## North Liberty Planning Commission

## NORTH LIBERTY PLANNING COMMISSION MEETING NOTICE AND AGENDA

To: North Liberty Planning Commission
From: Dean Wheatley, Planning Director
Subject: Request of Hodge Construction Company to approve a rezoning of:

To: North Liberty Planning Commission From: Dean Wheatley, Planning Director Subject: Site Plan Approval Request (Lot 9, I-380 Industrial Park)

#### FRONT ELEVATION

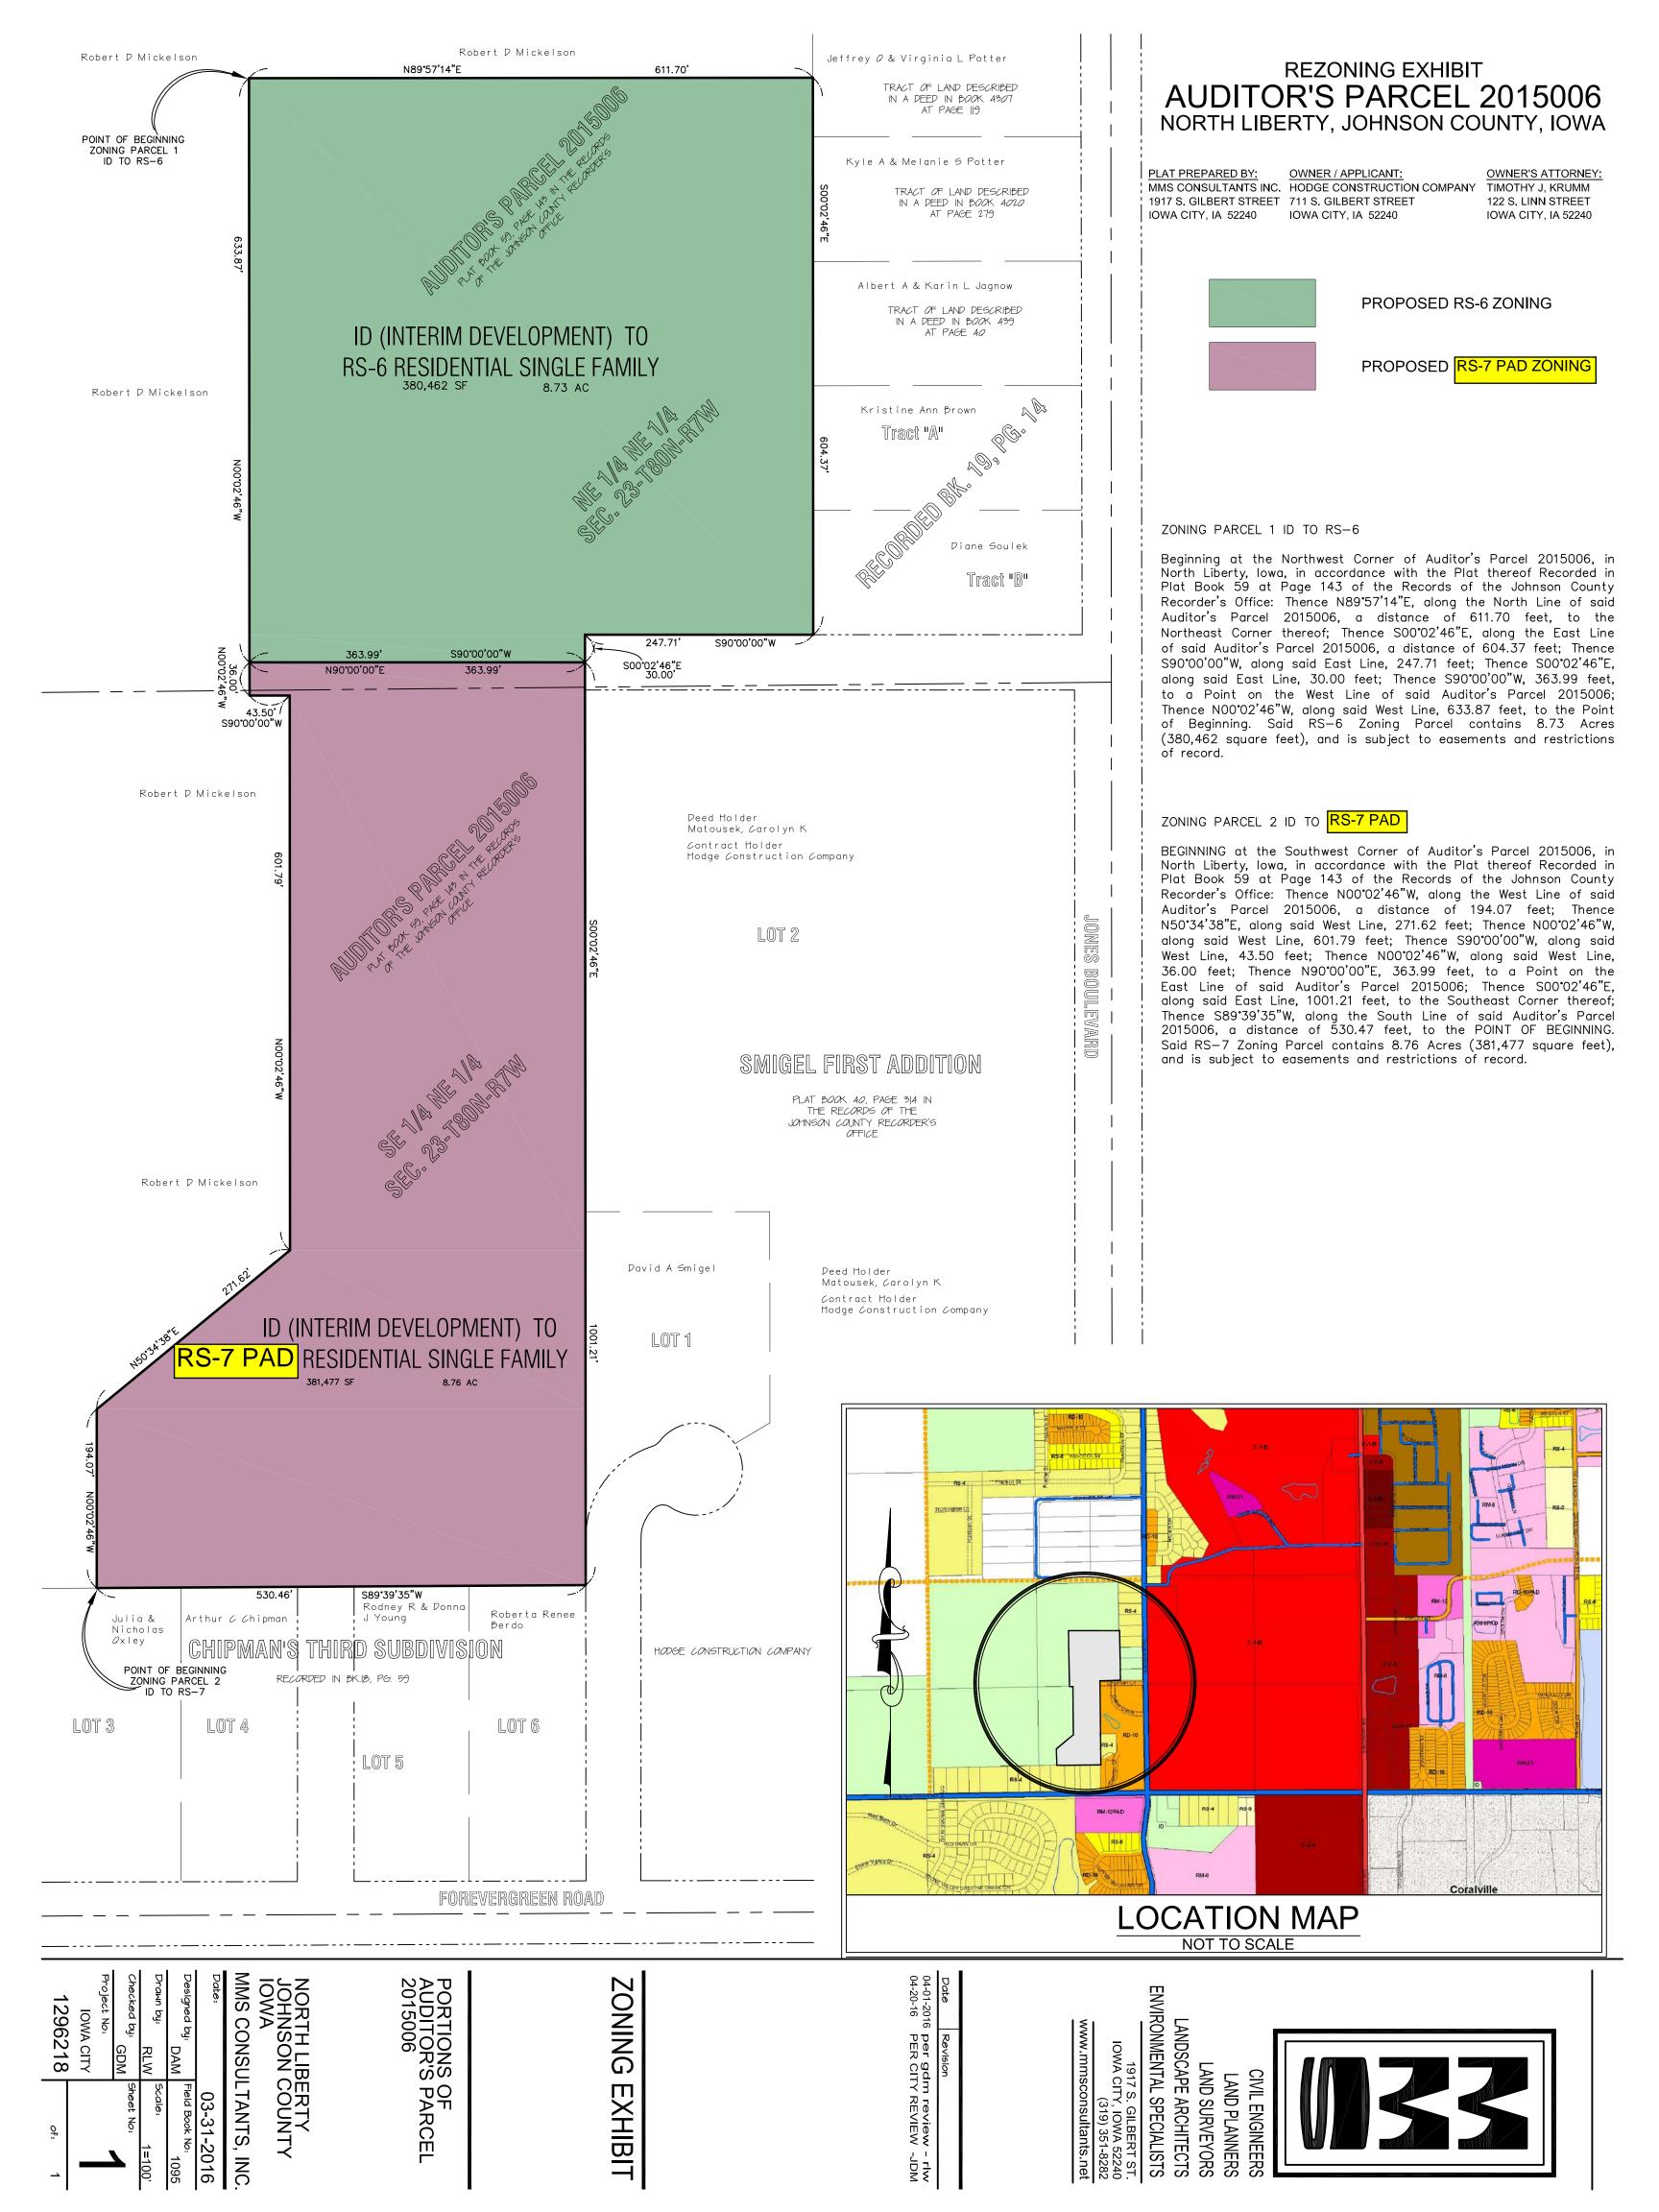
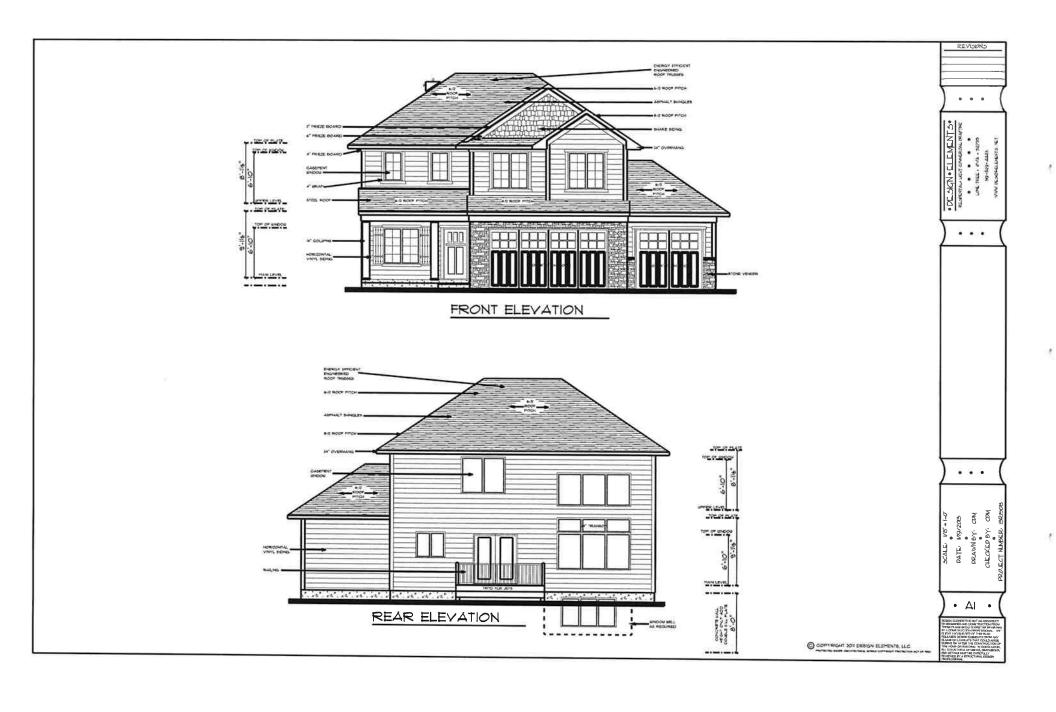
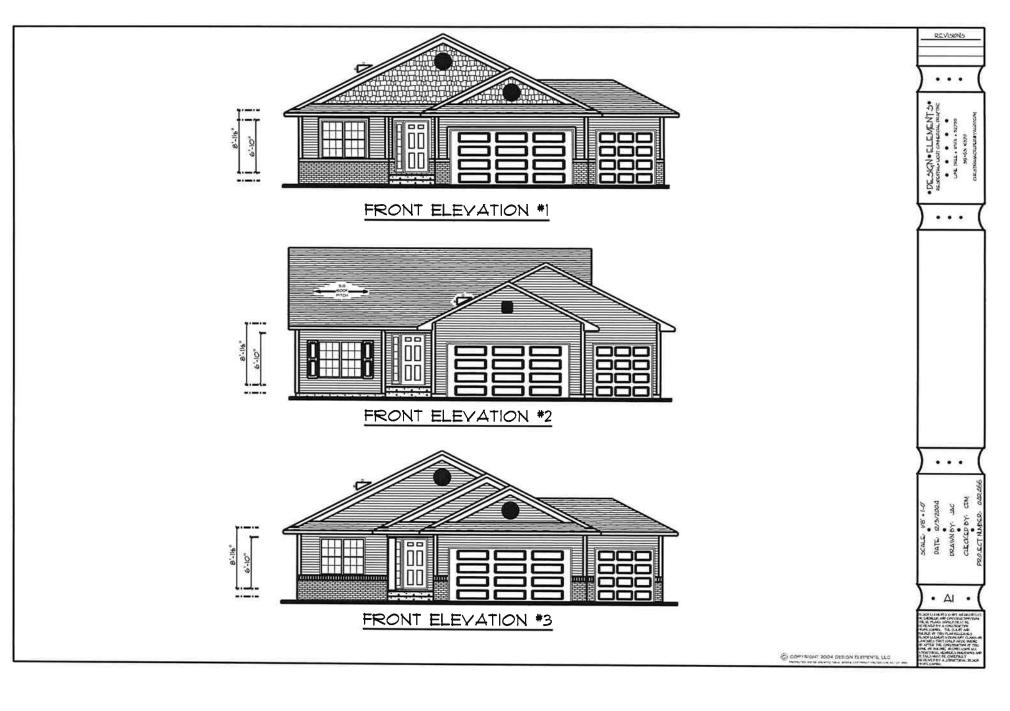
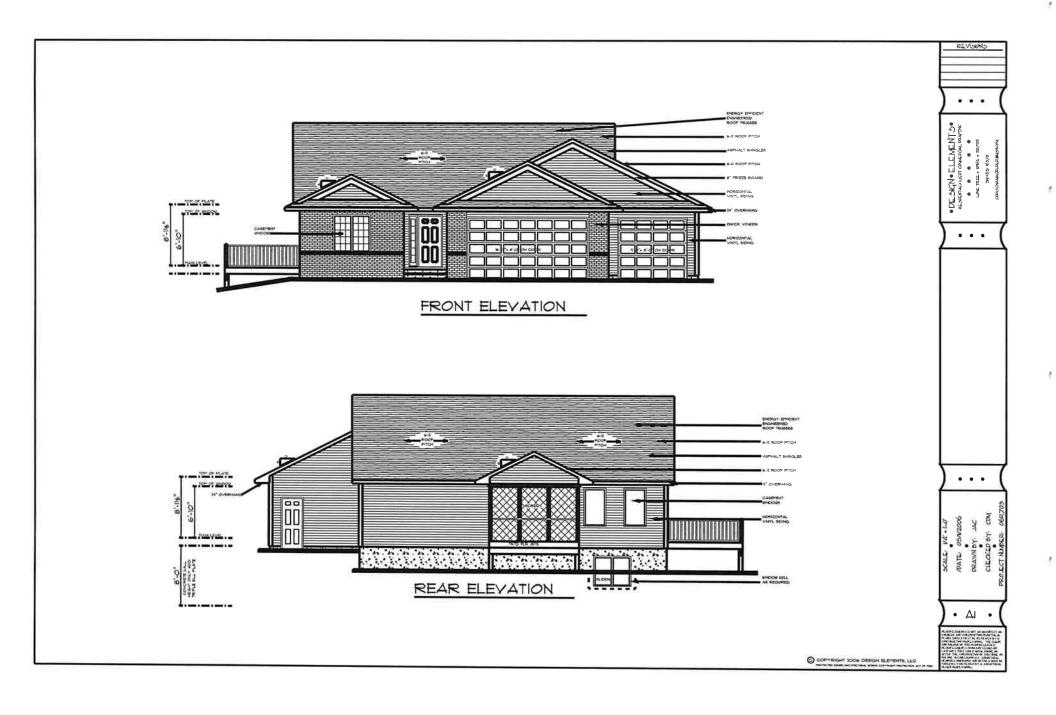
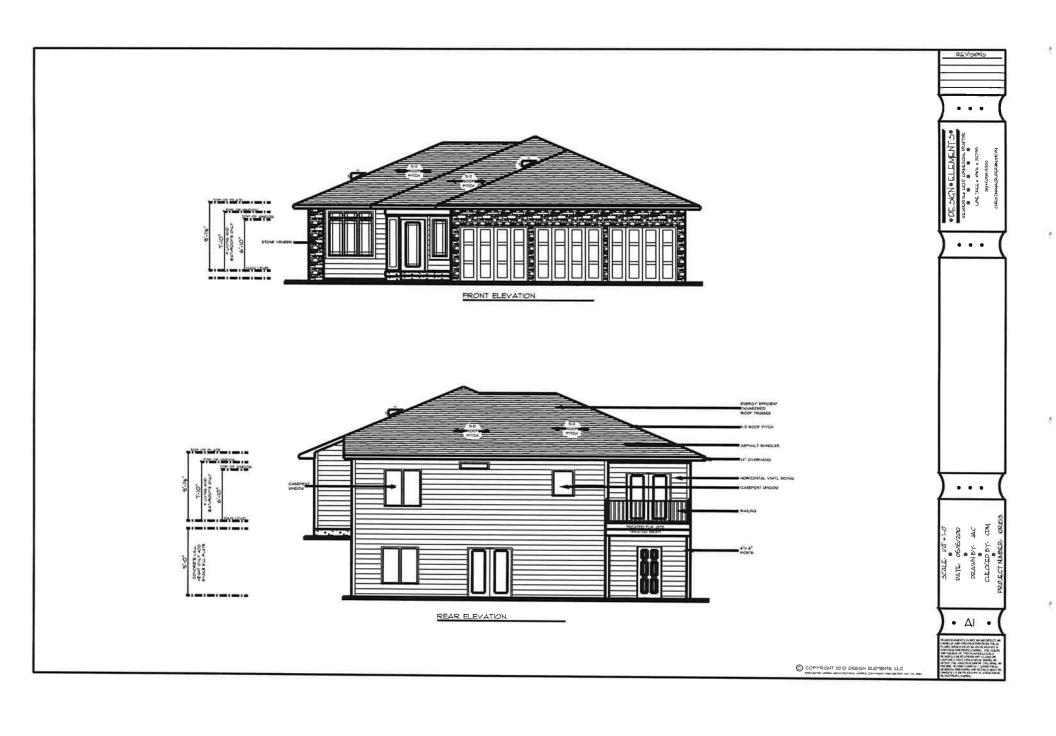
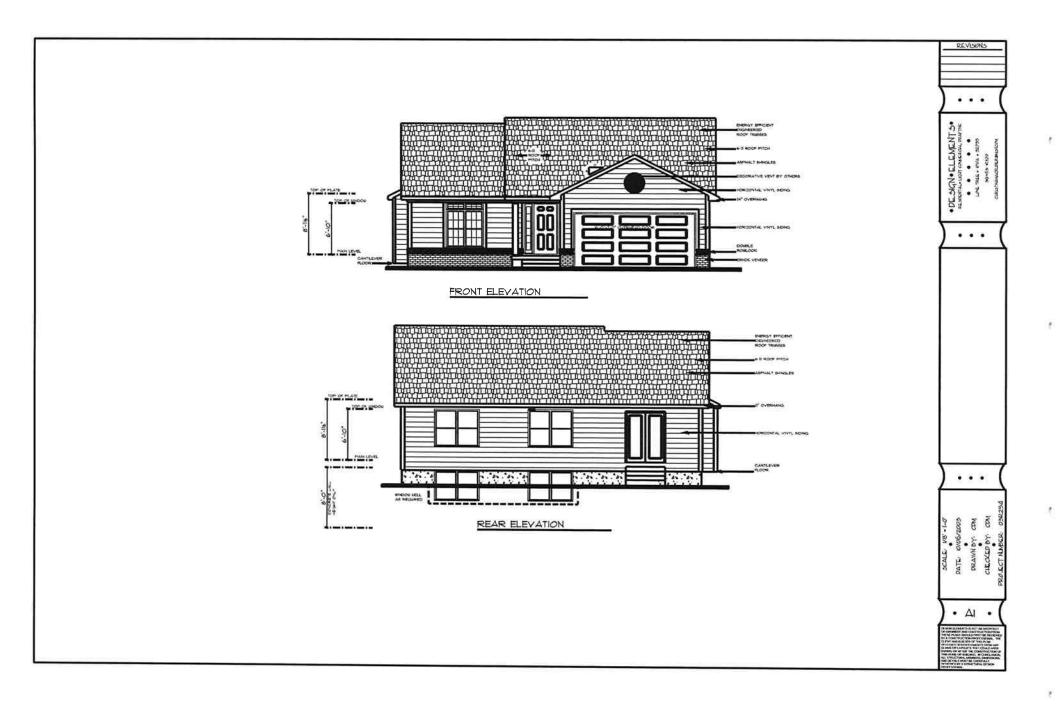
The PAD requires a variety of house designs, minimum two-stall garages for every lot, a two-inch caliper tree for the front yard of every lot, and at least 25% open space. In response the developer has submitted a number of sample building plans to be approved in concept with the rezoning. Because of building setback requirements, the open space requirement will almost certainly be exceeded.

The RS-7 district has specific requirements that must be considered, as noted above. This developer has chosen to request an RS-7 PAD and has submitted example house plans to complete that application.

- 1. That all building plans for houses on the RS-7 PAD property are reviewed and approved by the City Planner for general conformance with the plans submitted as part of this application, and
- 2. That the concept plan submitted for the entire contiguous property is considered to be general in nature and subject to change by the City or the developer in the future as development occurs.
